UNITED STATES PATENT AND TRADEMARK OFFICE

APPLICATION NO.	FILING DATE	FIRST NAMED INVENTOR	ATTORNEY DOCKET NO.	CONFIRMATION NO.
09/822,175	04/02/2001	Kazuhiko Yanagawa	HITA.0045	7332

Office Action Summary

DETAILED ACTION

FIG. 12A

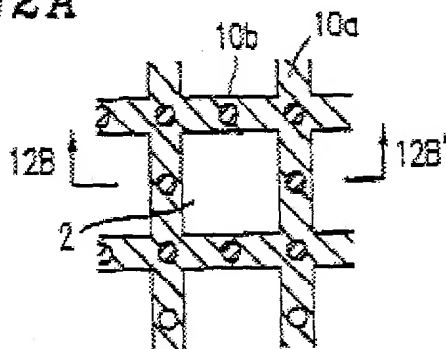
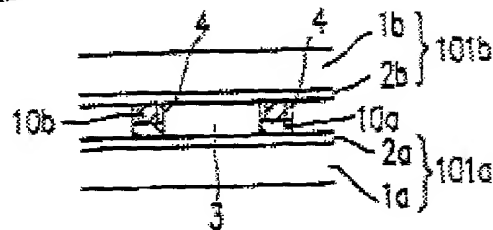
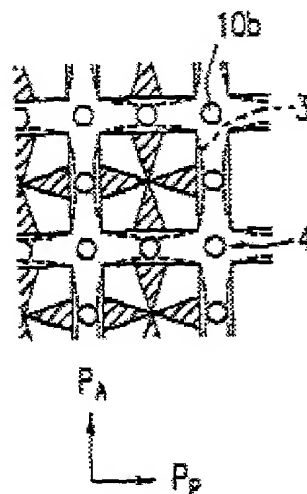
As to claims 35, 37, 38, and 40, Onishi discloses in Figures 12A-12C a liquid crystal display device of Example 1 (col. 17, line 60 through col. 33, line 34; especially col. 31, line 1 through col. 33, line 34) comprising a pair of substrates, 1a and 1b, as disposed to spatially oppose each other with a layer of liquid crystal material interposed therebetween and a seal material, 4, used for adhesion of one of the substrates to a remaining substrate, said seal material also having a function of encapsulating the liquid crystal material, wherein

a plurality of photolithographically formed (col. 31, lines 25-32) projection bodies, 10b, are precisely dispersed on one of said substrates in a predetermined shape thereof at a desired location thereon, and then said seal material is formed on said one of said substrates to bury said projection bodies therewithin (as illustrated in Figure 12B) (see also masks illustrated in Figures 11 and 13).

Onishi does not explicitly disclose a device wherein each of the projection bodies has a first contacting area different from a second contacting area nor does Onishi explicitly disclose projection bodies with at least one tapered surface extending between substrates. However, please note that commonly used photolithographic techniques inherently produce tapered walls in photolithographic material used for spacer (projection body) production due to non-zero dispersion of light through the mask. In other words, it is almost impossible to avoid tapered spacers when photolithography is used as the method of manufacture of said spacers. Therefore, examiner maintains the

spacers of Onishi, being photolithographically produced, are almost certainly tapered and would meet Applicant's structural limitations as claimed despite the lack of explicit disclosure of taper by Onishi.

As to claims 36 and 39, Onishi discloses in Figures 12A-12C a liquid crystal display device of Example 1 (col. through col. 33, line 34) the liquid crystal display device as recited in claim 36, wherein said plurality projection bodies are parallel-disposed (columns are parallel to each other and rows are parallel to each other, per Figure 12C).

FIG. 21E

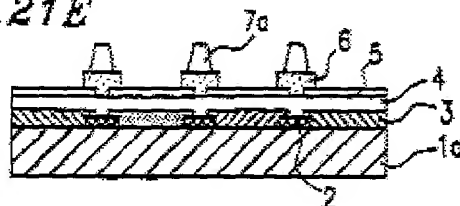
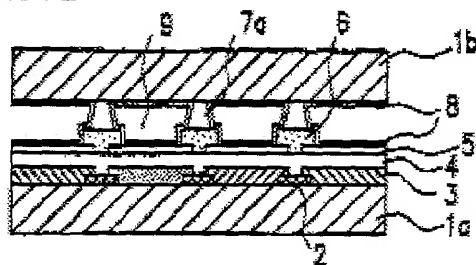
Kishimoto teaches in conventional example one (col. 26, line 58 through col. 27, line 56) Figures 21E and 21F, the use of tapered pillar-like protrusions, 7a [Applicant's projection bodies with a first contacting area different (larger) from a second contacting area (smaller) and with at least one tapered surface extending between substrates], as an art recognized configuration suitable for the intended purpose of forming spacers to achieve satisfactory cell gap.

Kishimoto is evidence that ordinary workers in the art of liquid crystals would find the reason, suggestion, or motivation to add projection bodies having a first contacting area larger than a second contacting area wherein said projection bodies have at least

one tapered surface extending between substrates as an art recognized configuration suitable for the intended purpose of forming spacers to achieve satisfactory cell gap.

Therefore, it would have been obvious to one having ordinary skill in the art of liquid crystals at the time the invention was made to modify the LCD of Onishi with projection bodies having a first contacting area larger than a second contacting area wherein said projection bodies have at least one tapered surface extending between substrates of Kishimoto as an art recognized configuration suitable for the intended purpose of forming spacers to achieve satisfactory cell gap (MPEP 2144.07).

FIG. 17

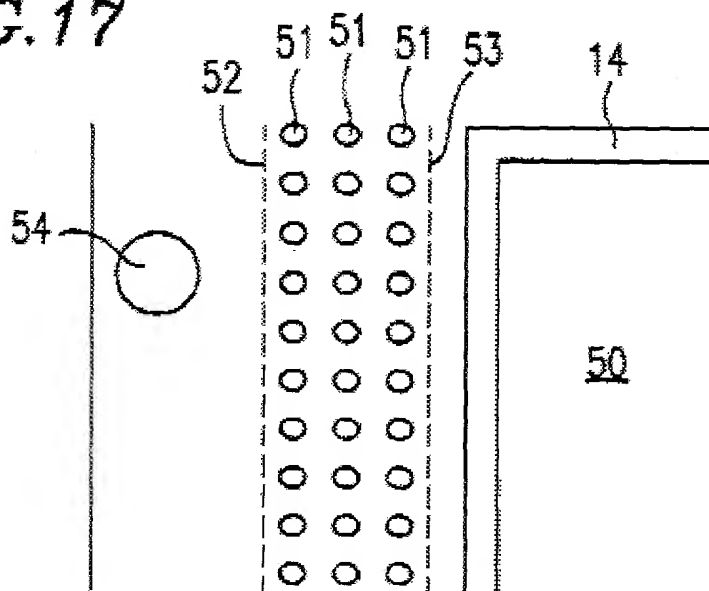
Nakahara teaches in Figure 17 a device comprising a plurality of parallel-disposed sealant particles, 51, (Applicant's projection bodies) about the perimeter of the display area to minimize stress distortion and waviness of the glass plates (col. 12, line 66 through col. 13, line 8).

Nakahara is evidence that ordinary workers in the art of liquid crystals would find the reason, suggestion, or motivation to add a plurality of parallel-disposed sealant

particles (Applicant's projection bodies) to minimize stress distortion and waviness of the glass plates

Therefore, it would have been obvious to one having ordinary skill in the art of liquid crystals at the time the invention was made to modify the LCD of Onishi in view of Kishimoto which has photolithographically formed projection bodies buried in seal material, with the plurality of parallel-disposed sealant particles (Applicant's projection bodies) about the perimeter of the display area of Nakahara to minimize stress distortion and waviness of the glass plates.
